Flight Procedures Cover Page	Task Action: Amendment	Task Type: IAP	Estimated Chart Date: 03/26/2020	APWS Task ID: E99E4369AC18420DBA3AA03771437723	APWS Request ID: B856F18FC2784FF6B862E69D01FD38CF
Procedure: VOR OR TACAN RWY 26 AMDT 20A		Enroute: NO	Specialist: Blanco, Joseph		Agreement Number:
Airport ID: TJSJ	Airport Name: LUIS MUNOZ MARIN INTL	Airport City: SAN JUAN			State:
Facility ID: SJU	Facility Type: VORTAC	Flight Inspection Remark Type:

Procedure Comments:
ABBREVIATED AMENDMENT

VOR or TACAN RWY 26
LUIS MUNOZ MARIN INTL (SJU)(TJSJ)

OLD

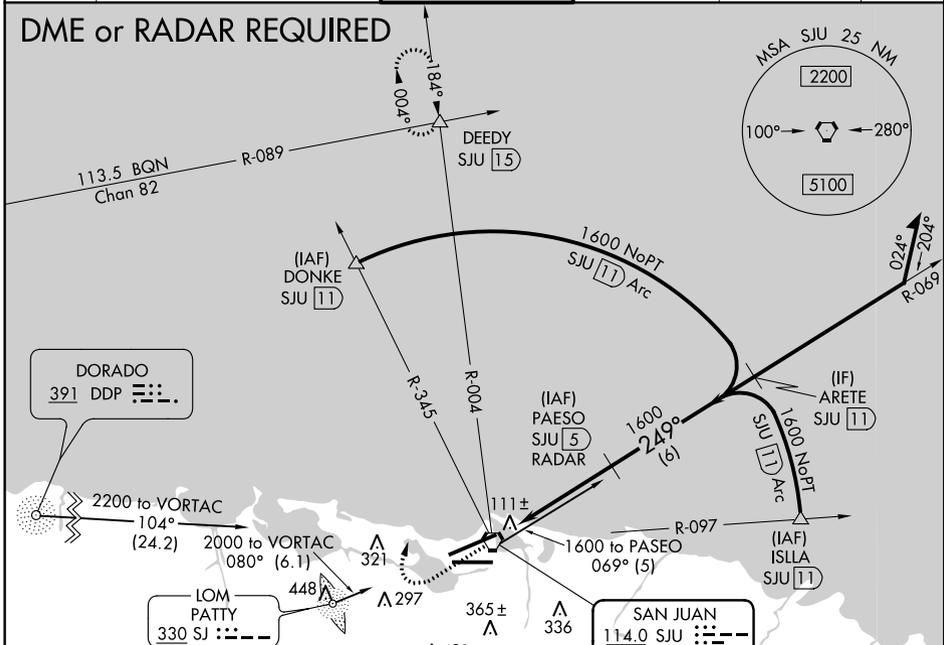
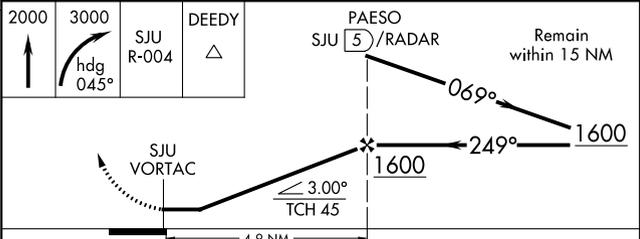
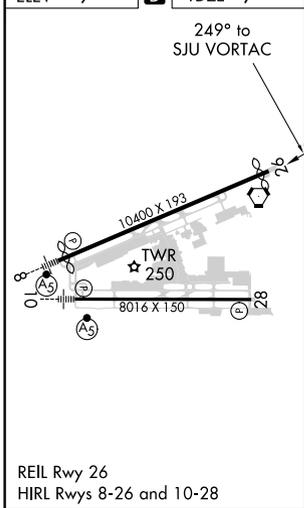
DEDDY FIX MAKEUP IS WITH SJU AND BQN. BQN HAS BEEN DESTROYED BY A HURRICANE AND IS NOT FEASIBLE TO REPAIR. REMOVE BQN FROM THE FIX MAKEUP AND CHANGE THE FIX TYPE TO WP AND DME ONLY FOR ALL PROCEDURES.

⚠ Visibility reduction by helicopters NA. MISSED APPROACH: Climb to 2000 then climbing right turn to 3000 via heading 045° and SJU VORTAC R-004 to DEEDY INT/SJU 15 DME and hold.
